RAIB Report: Loss of brake control on a sleeper train approaching Edinburgh on 1 August 2019

I write to provide an update¹ on the action taken in respect of recommendation 1 addressed to ORR in the above report, published on 28 May 2020.

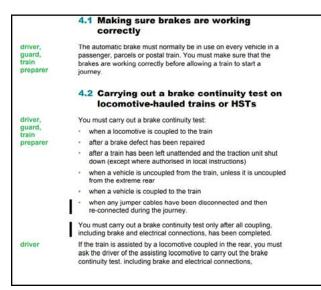
RSSB, in consultation with its members, should amend the wording of section 4.2 of Rule Book module TW1 (GERT8000-TW1 – 'Preparation and movement of trains') to make it clear that the brake continuity test should be carried out after all coupling-related activities have been completed.

Section 4.2 was amended to state that a brake continuity test on a locomotive-hauled train or HST must only be carried out after completing all coupling including brake and electrical connections. A brake continuity test must also be carried out if any jumper cables have been disconnected or reconnected during a journey:
